Access Compliance Report Public Rights-of-Way (Pedestrian Signals)

Main Street: HEWES_AVE Cross Street: 17TH_ST Location: NE

ADA ID: SGRK211008122640 Signal Type: One Push Button-Non APS Overall Compliance: No Severity Scores: BTN 1: 45 BTN 2: N/A No BTN: N/A

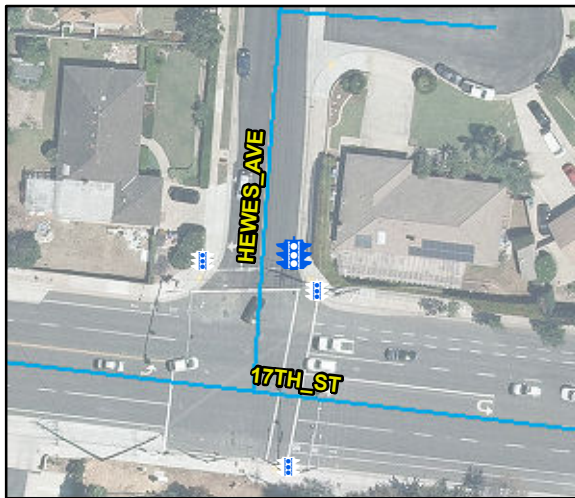
Yes B 1 Closed Fist Operation?		Yes	N/A	B 2 Closed Fist Operation?	N/A
Yes B 1 Diameter (in)		2	N/A	B 2 Diameter (in)	N/A
N/A B 1 Crossing Direction		W	N/A	B 2 Crossing Direction	N/A
No B 1 DistanceTo XWalk (in)		72	N/A	B 2 DistanceTo XWalk (in)	N/A
Yes B 1 DistanceTo Curb (in)		24	N/A	B 2 DistanceTo Curb (in)	N/A
Parcel Identification Number		395-571-27			
Google Street View Link

Possible Solutions: Replace Signal Push Button With APS Button. Remove & Replace Sign.
